Subject: Approval of Change Order No. 1 with Dan Hart Patrol Service, LLC for the Landfill Cell No. 7 Project No. 2112, for an increase of \$440,156.56, for a new contract price of \$2,233,491.38.

CHANGE ORDER NO.: 1

Owner:	City of Watertown	Owner's Project No.:	2112
Engineer:	Houston Engineering Inc.	Engineer's Project No.:	7716-0020
Contractor:	Dan Hart Patrol Service, LLC.	Contractor's Project No.:	
Project:	WRLF Cell 7 Construction

Watertown Regional Landfill Cell 7

LEACHATE COLLECTION PIPE CELL 7	SHEET
PROJECT NO. 7716-0020	7

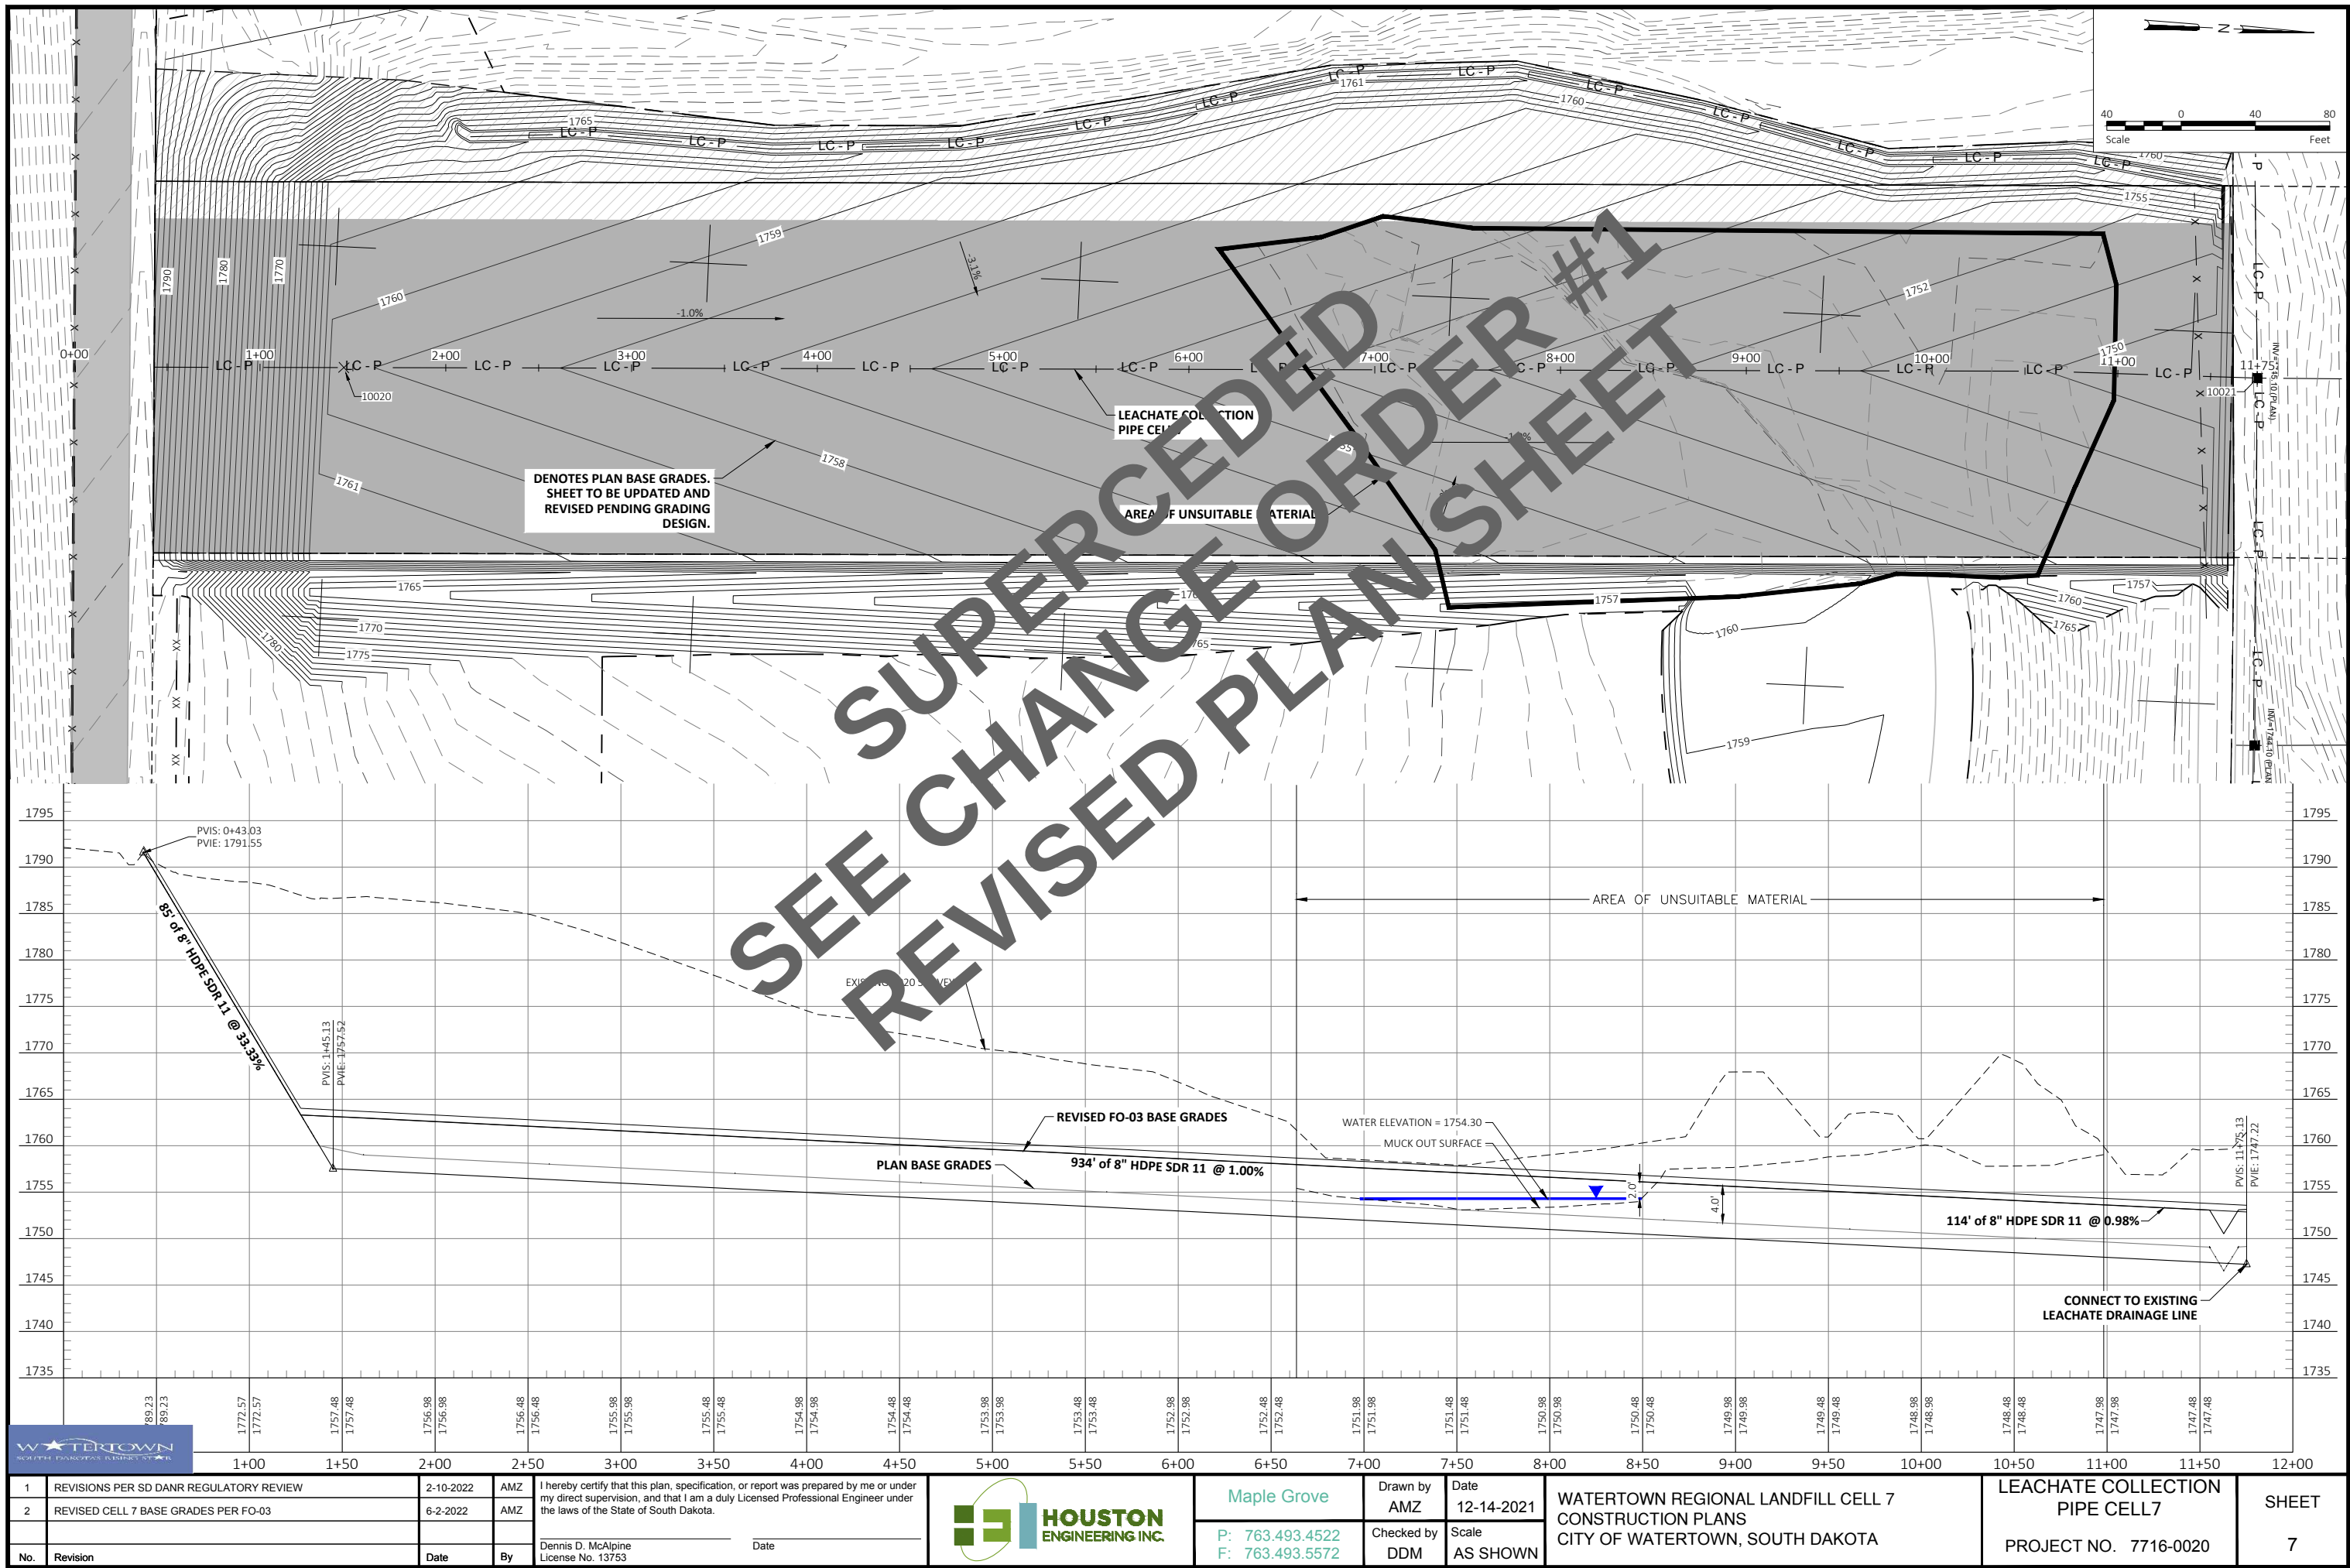
The discovery of a significant volume of unsuitable soils materials will necessitate removals in excess of the contract identified (estimated) subgrade removal line item. During topsoil removal activities crews discovered a large area of organic materials within the Phase 1 Cell 7 construction area. The area encompasses the entire width of proposed Cell 7 and extends approximately 800-feet south of the northern boundary of the Cell. As noted during a 5/19/2022 onsite meeting and subsequent weekly progress meetings the unsuitable/organic materials shall be removed so that compactable materials can be placed to provide a stable foundation for the proposed Cell 7 base liner system.

- The base grades (Cell floor only) within Cell 7 be raised 4ft. It is anticipated that this design change will provide the necessary separation from the exposed subgrade to allow for construction to proceed despite the area/adjacent soils not being fully drained.
- Modify the proposed leachate collection trench to remove the 2-foot grade change (depression) from the adjacent base grades of the Cell floor. The leachate collection pipe will be placed directly on the "v-graded" transition of the Cell floor base grades at the center of the Cell.

We are aware that this proposed work will necessitate changes to the construction workflow and associated equipment. We anticipate that the work north of the subgrade removal area will not be able to be completed with scrapers as initially intended. Instead, the work will need to be completed with truck and excavator placement as result of limited accessibility to the area. Per your 5/26/2022 Change of Directive memo, Dan Hart Patrol Service proposes that the additional unsuitable/organic materials be removed for a unit price of \$9.59/CY. The replacement

materials will also be placed at the \$9.59/CY unit price until conditions improve to allow for scraper placement operations and associated placement at the contract unit price of 2.27/CY for clay liner placement. Portions of the Cell floor base liner previously excavated will need to be raised (filled) to accommodate the revised liner elevation. This work will be completed as clay liner placement at the contract unit price of \$2.27/CY. Raising the grade of the Cell floor base grades will also result in two (2) deducts. The proposed change will result in a reduction in the excavation necessary to establish the Cell floor base grades on the portion(s) of Cell 7 not yet excavated to grade.

H:\JUNIT700\716-0020 WRLF Cell 7CAD\Plans\716_Pro & Exst Grades_F0w3 (Revised Sheet 7).dwg-7 LEACHATE COLLECTION PIPE CELL 7-6-8-2022 12:11 PM: (asigen)

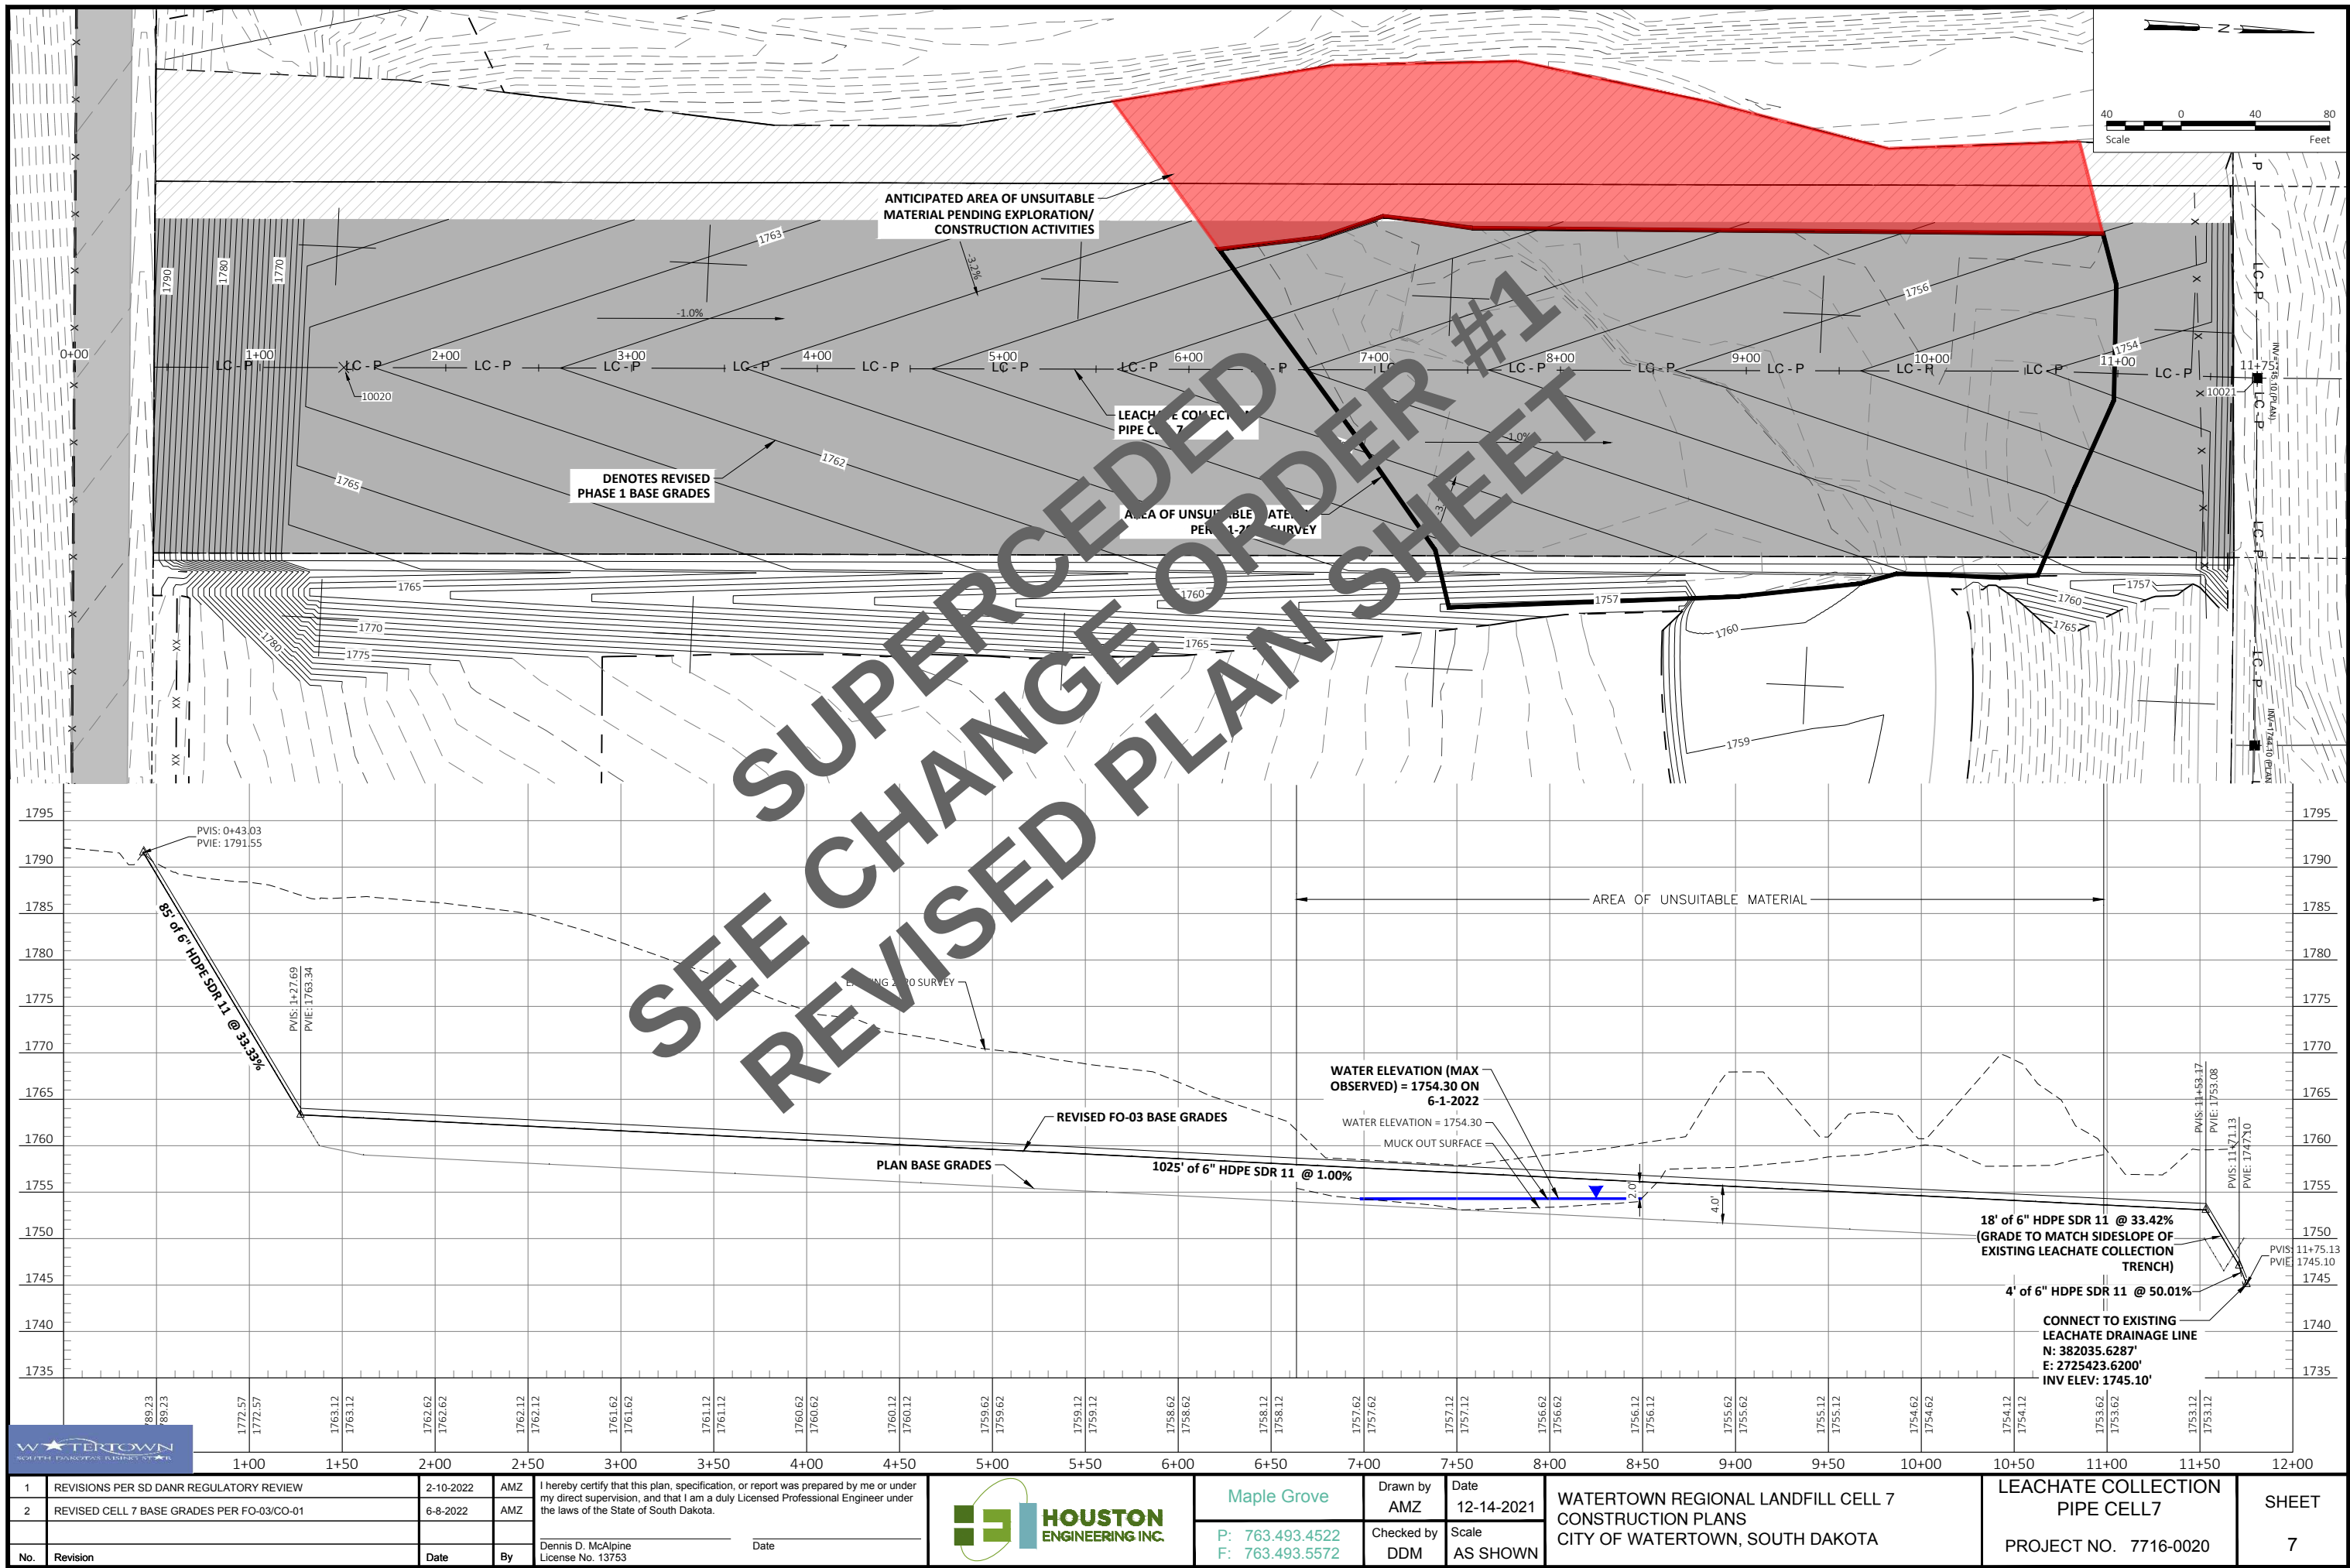
Drawing(s) / Details (s): Plan Sheet 7 – Leachate Collection Pipe denoting revised Cell 7 grades
Plan Sheet 16 – Point Schedule denoting revised Cell 7 grades
Plan Sheet 22 – Liner Details revising leachate collection trench

To maximize the separation distance from the bottom of the base liner and the fill materials within the unsuitable material removal/replacement area the leachate collection trench has been modified. The revised plan identifies removal of the 2-foot depression to install the trench. The trench (geotextile/pipe/rock combination) will be placed atop the channel created via the intersection of the western and eastern slopes (3% inward) at the middle of the Cell.

H:\JUN17\00716\716-0020 WRLF Cell 7\CAD\Plans\716_Point Schedule_Revised.dwg-16 POINT SCHEDULE-6/8/2022 3:04 PM-(ezgan)

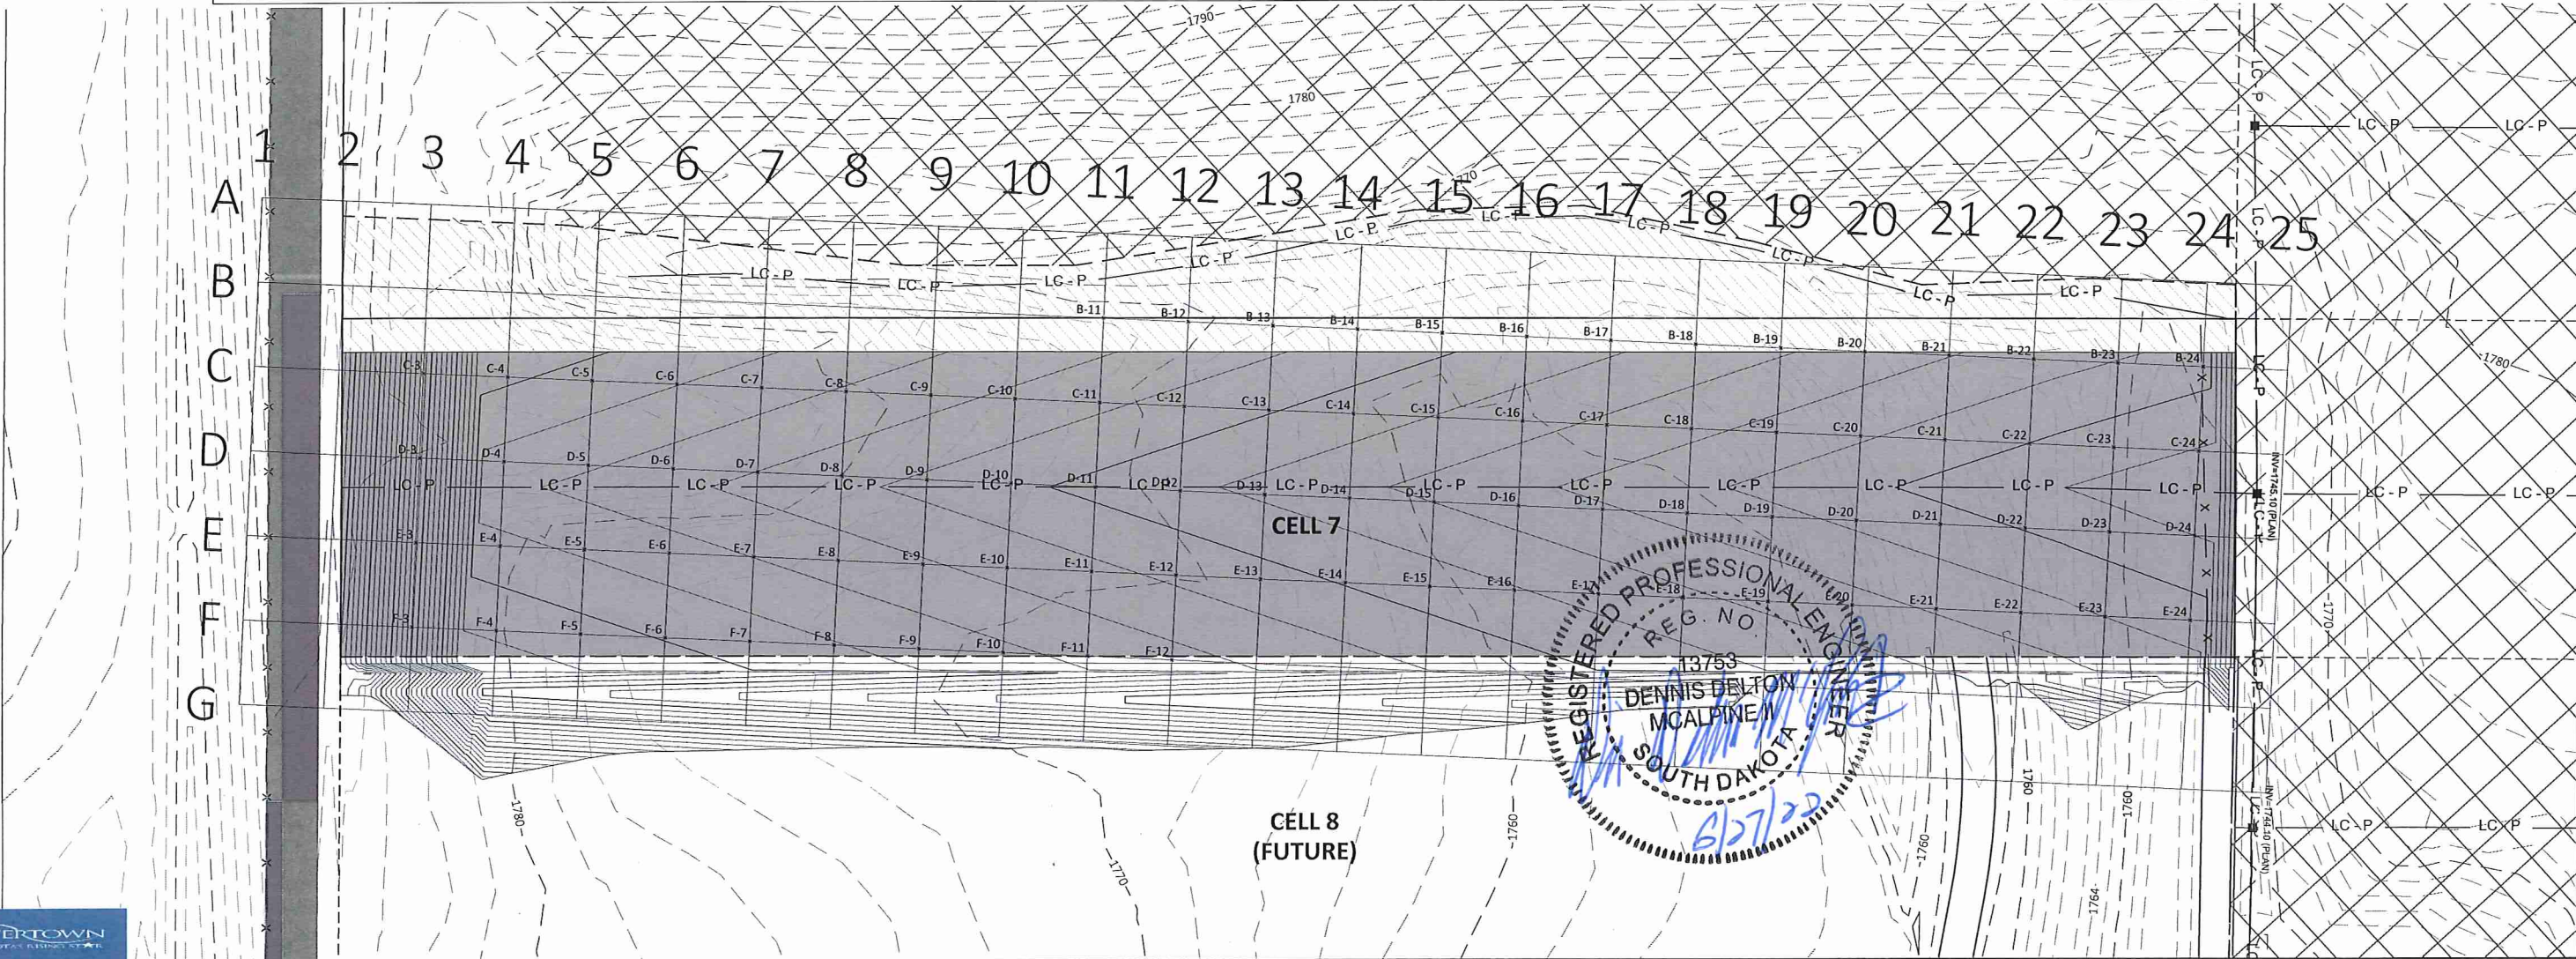
1	REVISED CELL 7 BASE GRADES PER FO-03/CO-01	6-8-2022	AMZ	I hereby certify that this plan, specification, or report was prepared by me or under my direct supervision, and that I am a duly Licensed Professional Engineer under the laws of the State of South Dakota.	Maple Grove	Drawn by AMZ	Date 12-14-2021	WATERTOWN REGIONAL LANDFILL CELL 7 CONSTRUCTION PLANS CITY OF WATERTOWN, SOUTH DAKOTA	POINT SCHEDULE	SHEET
No.	Revision	Date	By	Dennis D. McAlpine License No. 13753	P: 763.493.4522 F: 763.493.5572	Checked by DDM	Scale AS SHOWN	PROJECT NO. 7716-0020		16
